1 1-0010-02-Mntg This document contains suggested text to resolve comments regarding P802-REVc-d1.0.

Figure 1—An example of a bridged IEEE 802 network

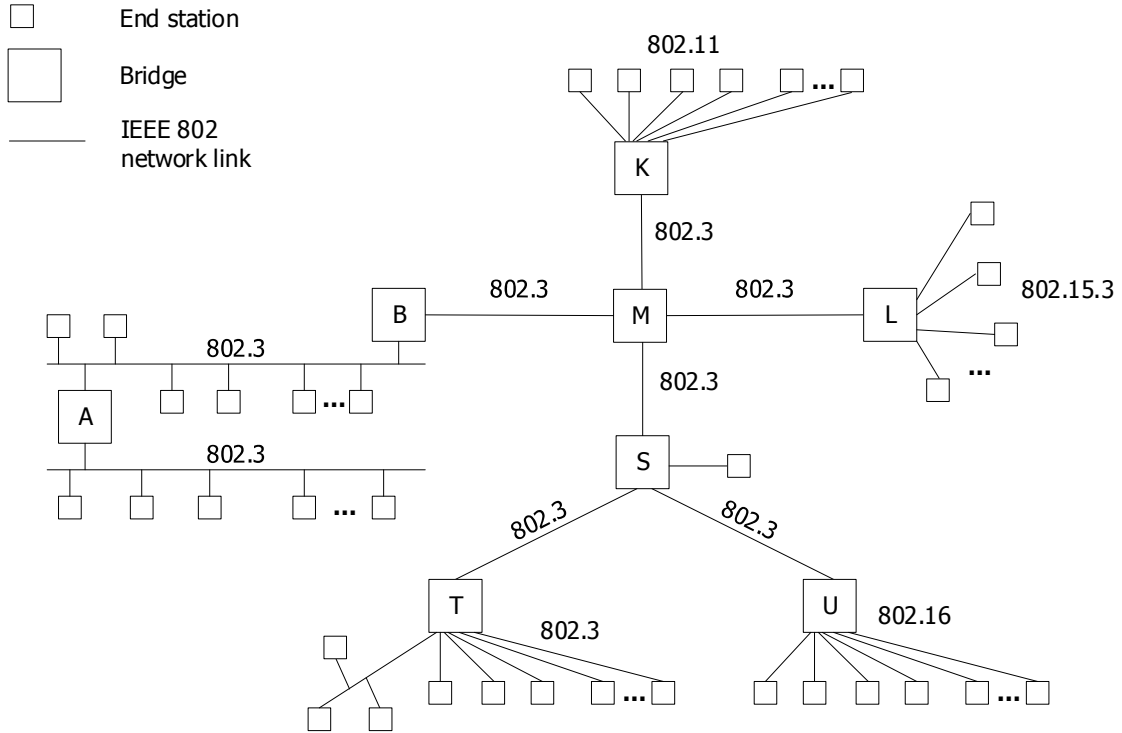
12 *Subclause 5.2.3.6 is now 5.2.3.8 with the changes shown to address CID 4, CID 37, CID 59, and CID 94*

20 Figure 1 illustrates an example of a bridged IEEE 802 network that can be configured with bridge-style
21 interconnection. The bridges A and B, and the IEEE 802.3 LAN configurations to which they attach, are
22 typical of the older style of bridged IEEE 802 network in which a bridge interconnects a small number of
23 access domains, each containing many end stations, as is similar with K and L and ~~M~~their IEEE 802.17™
24 ring. ~~The IEEE 802.17 ring~~ and the IEEE 802.3 connections ~~to M and those~~ between S and T and S and U
25 form backbone networks. On the other hand, the bridges S, T, and U function as bridges that combines ~~IEEE~~
26 ~~802.17~~, IEEE 802.3, and IEEE 802.16™ networks. ~~S and M are is~~ backbone bridges, handling a number of
27 network attachments. T and U are bridges that support multiple end stations, with connection to a backbone
28 network. B and K also provide access to a backbone network. The end station shown connected to S by a
